Determination 2011/027

Subject to clarification of 30 May 2011¹

Surface water runoff onto other property at 90 Paremata Road, Porirua

Figure 1: Site plan of the reserve showing the properties

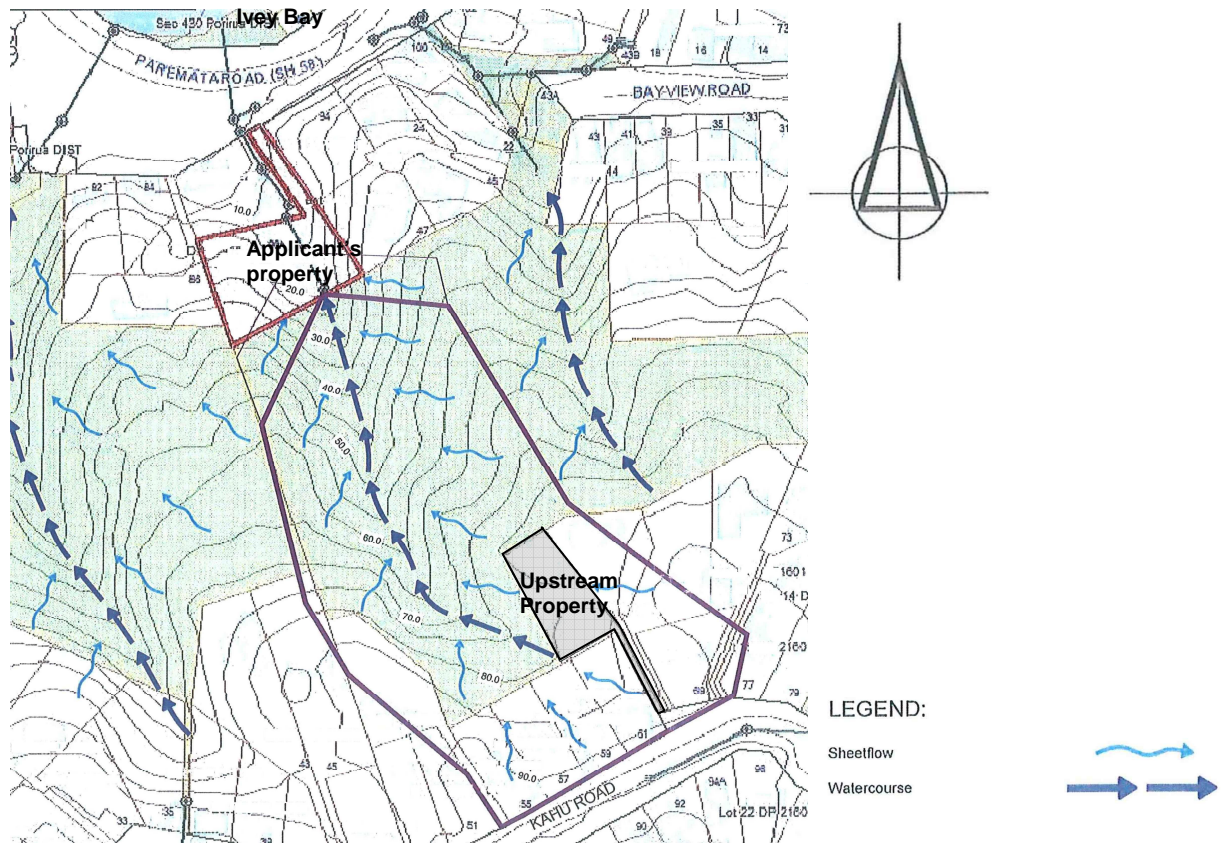
- 2.5 The upstream property is situated approximately 125 metres (in plan) above the applicants' property, and is one of several properties situated along, or down, the slope from Kahu Road at the top of the gully. The dwelling on the upstream property was constructed in the 1960's and was extended in 1974 and 1978. During 2003 to 2005, a double garage, driveway and associated siteworks were constructed on the site.

- 2.6 The surface water from the upstream property discharges from the site through four outlets into the natural gully. Three of these outlets were constructed when the double garage was built in 2004. The surface water from a common driveway leading to the upstream property discharges at a corner of that site into a sump.

- 6.2.3 When the expert investigated the upstream property, the common access way sump serving several Kahu Road properties (refer paragraph 2.6) was blocked by debris. The expert was of the opinion that this would cause surface water run-off to pond at this location, which would then run overland on a similar path to the alignment of the discharge pipe from the sump.

- 6.2.4 The expert also noted that the four surface water outlets discharging from the upstream property are 'positioned in a spread in order to prevent concentration of flows at one location and to minimise nuisance'.
